E5515B-08C

S E R V I C E N O T E

E5515B Wireless Communications Test Set (8960 Series)

Power-On DSP Initialization Failures Require Replacement of the DSP Assembly

Figure 1 – DSP initialization bootup failure during test set power-on.

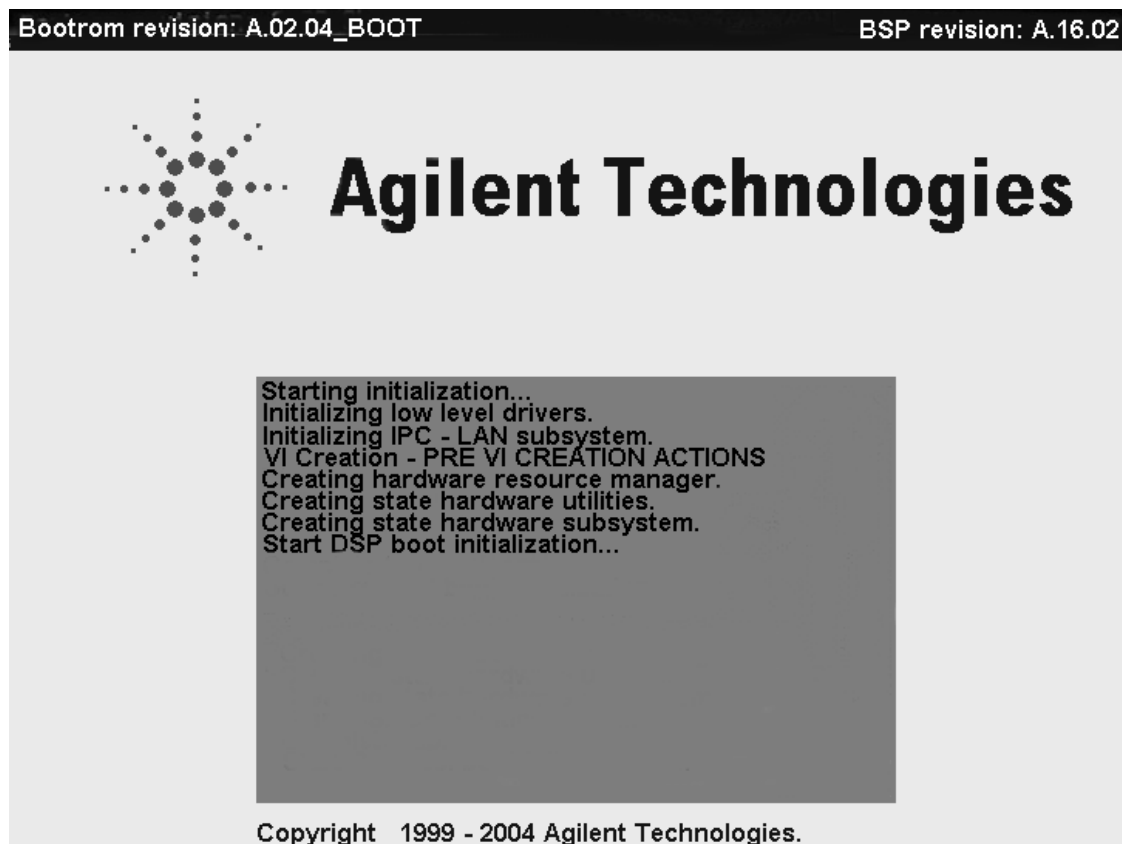
- **Figure 1** shows the typical point in the test set bootup process where the DSP fails to initialize. The bootup process may stop here and then re-boot, or will eventually complete the bootup process after multiple attempts to initialize the DSP assembly.

If the test set fails to bootup correctly, takes longer than normal to bootup, or displays messages noted below, replace the DSP Assembly using exchange repair kit E5515-69843. Verify that the test set boots up and operates normally. Re-calibration is not required.
